Access Compliance Report

Public Rights-of-Way

Intersection ID: 4129	Main Street: ANDREW_JAMES_DR	Cross Street: RENEE_SAVANNAH_LN	Location: NE
ADA ID: A8BE4A81911E	Ramp Type: Perp	Initial Pass/Fail: Fail	Overall Compliance: No
Severity Score: 21.25			
Codes/Mitigation Info/Possible Solution		Field Measurements/Component Compliance

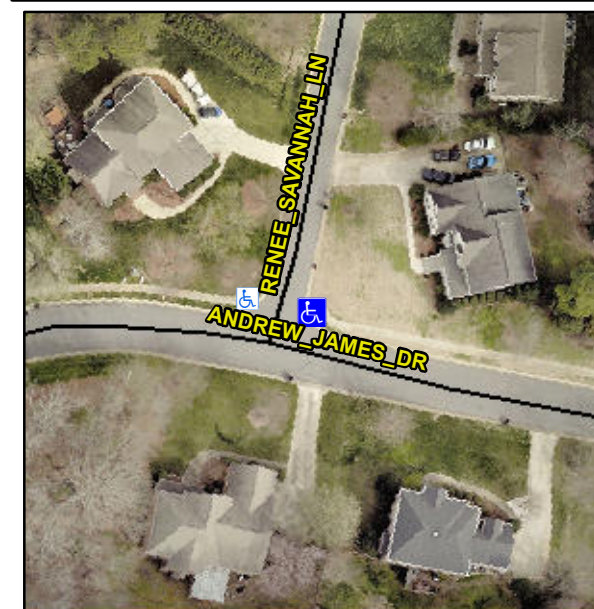
Not Found, R304.5.1, R304.2.2

Compliance	Description	Data	Compliance	Description	Data
N/A	Ramp Length (in)	96.0	No	Ramp Slope (%)	10.4
No	Ramp Width (in)	47.0	Yes	Ramp XSlope (%)	0.3
N/A	Flare Type LT	N/A	N/A	Flare Type RT	N/A
N/A	Flare Slope LT (%)	N/A	N/A	Flare Slope RT (%)	N/A
N/A	Flare Traversable LT?	N/A	N/A	Flare Traversable RT?	N/A
N/A	Landing Length (in)	N/A	N/A	DWS Provided?	N/A
N/A	Landing Width (in)	N/A	N/A	DWS Contrast?	N/A
N/A	Landing Slope (%)	N/A	N/A	DWS Length (in)	N/A
N/A	Landing X Slope (%)	N/A	N/A	DWS Full Width?	N/A
N/A	Landing Curb? (Y/N)	N/A	N/A	DWS Offset (in)	N/A
N/A	Shared Landing?	N/A			
N/A	Gutter Ponding?	N/A	N/A	Gutter Slope (%)	N/A
N/A	Gutter Lip Ht (in)	N/A	N/A	Gutter X Slope (%)	N/A
N/A	Painted X Walk1?	No	N/A	Painted X Walk2?	N/A
	X Walk 1 Direction	To NW		X Walk 2 Direction	N/A
N/A	X Walk 1 Width (in)	N/A	N/A	X Walk 2 Width (in)	N/A
	X Walk 1 Slope (%)	1.5		X Walk 2 Slope (%)	N/A
	X Walk 1 X Slope (%)	3.8		X Walk 2 X Slope (%)	N/A

Remove & Replace Entire Ramp.
